Modification K515-DC1

Type 515 Oscilloscope

Installs dc Fan Motor

The K515-DCl modification supplies a dc fan motor to enable the Type 515 Oscilloscope to operate on 50- to 800-cycle lines.

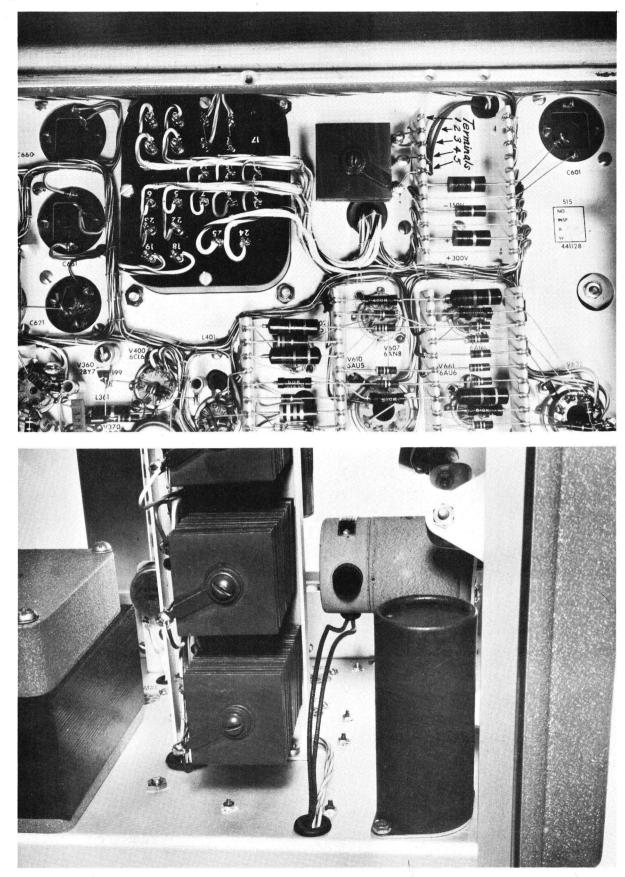
() 1. Unwire both fan motor leads at rear ceramic strip on under side of oscilloscope.

) 2. Remove air filter housing.

) 3. Remove fan motor ring and motor.

) 4. Remove ac motor and bracket from ring and replace with new dc motor and bracket.

() 5. Re-install ring, motor, fan blade and filter housing.

() 6. Feed new motor leads back through the same rubber grommet from which the old leads were removed.

() 7. Install rectifier stack on bottom of power deck, beside transformer. Use hole provided. Lugs should face ceramic strip.

() 8. Solder strap from inside rectifier lugs and one of the new motor leads to #5 slot (from outside of ceramic strip).

- () 9. Solder strap from middle rectifier lug and the other motor lead to #4 slot (from outside of strip).
- ( ) 10. Solder white-red lead to #3 slot (from outside of strip).
- ( ) 11. Connect strap from outside top lug to #2 slot (from outside of strip).
